SANTA FE COUNTY
IFB 2023-0032-PW/APS
CERRILLOS SENIOR CENTER AND
TURQUOISE TRAIL FIRE STATION #3

ADDENDUM NO. 1

L001

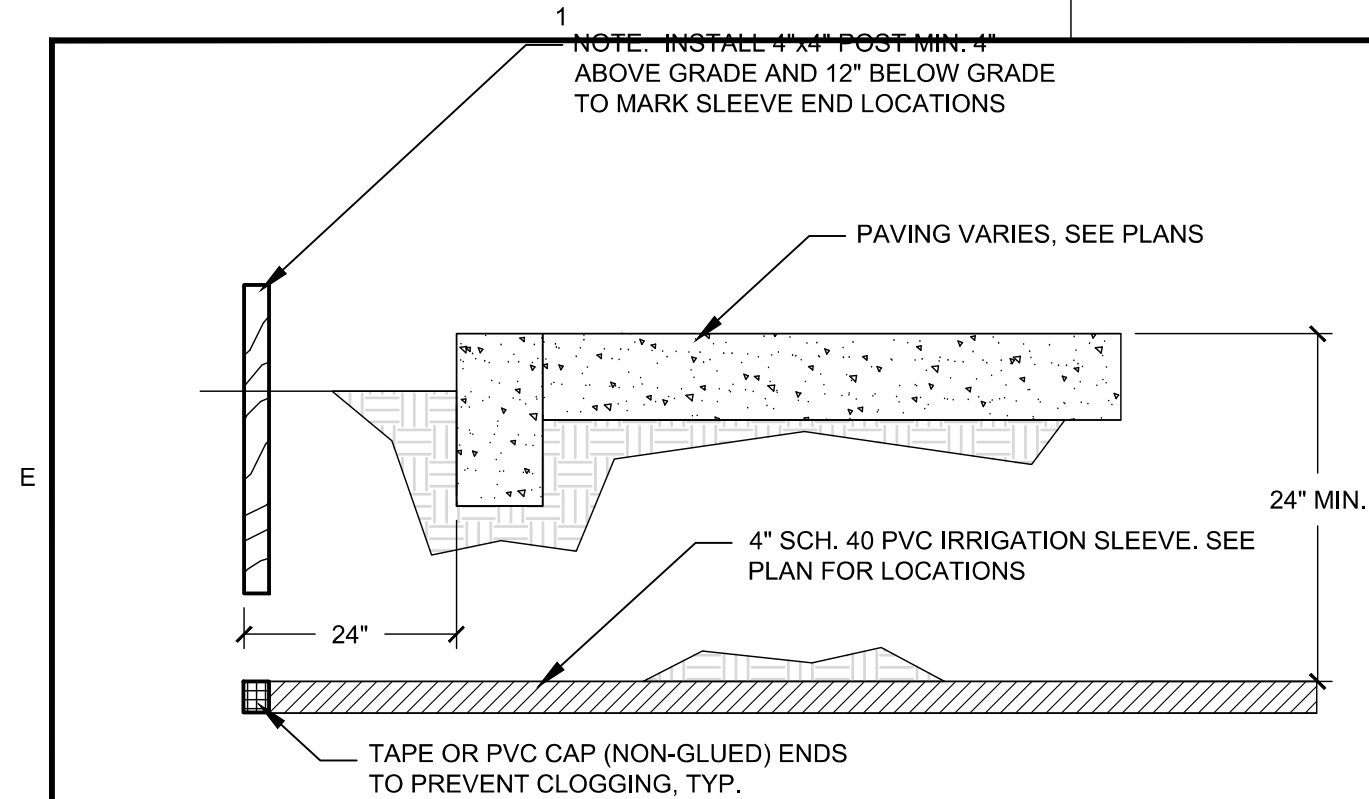
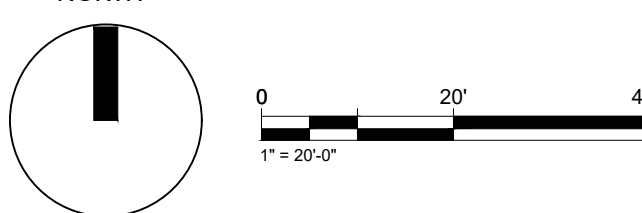
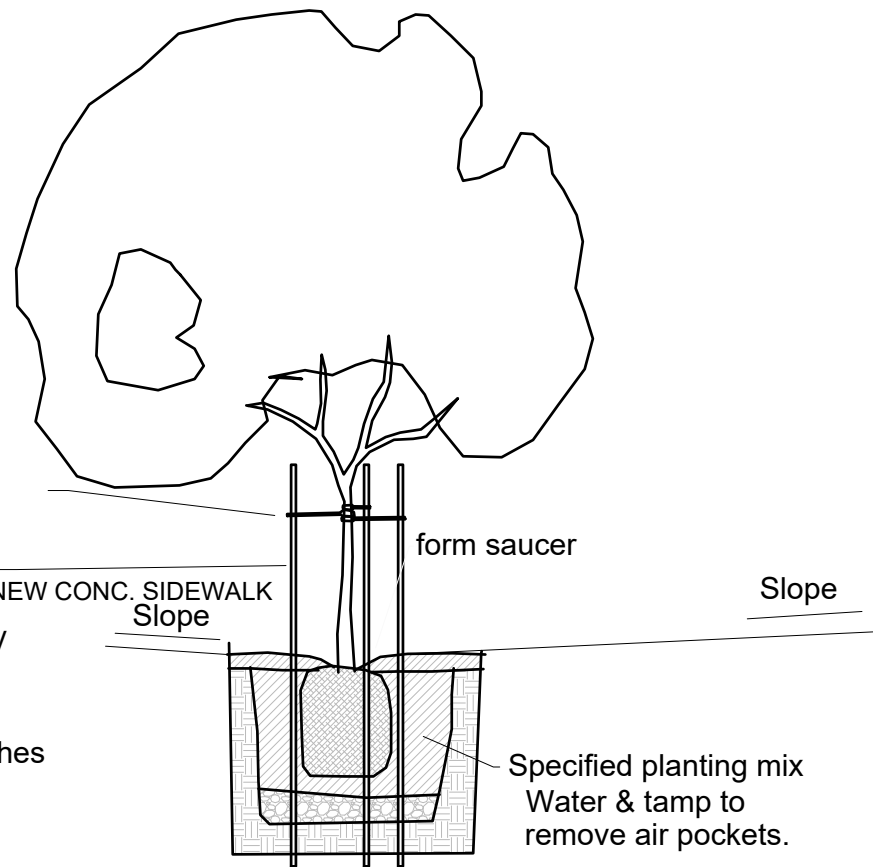
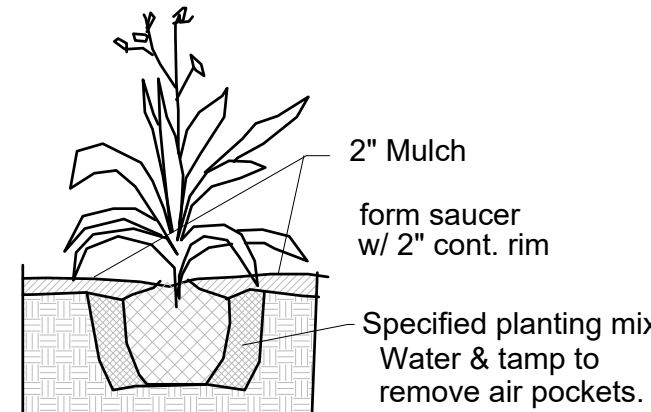
Question No. 1: The Sheet Index (plan sheet G001) lists sheet L001 – Landscape Plan and L002 – Irrigation Plan, but those sheets were not included in the plan set. When will they be made available?

Answer No. 1: Please see Attachment B.
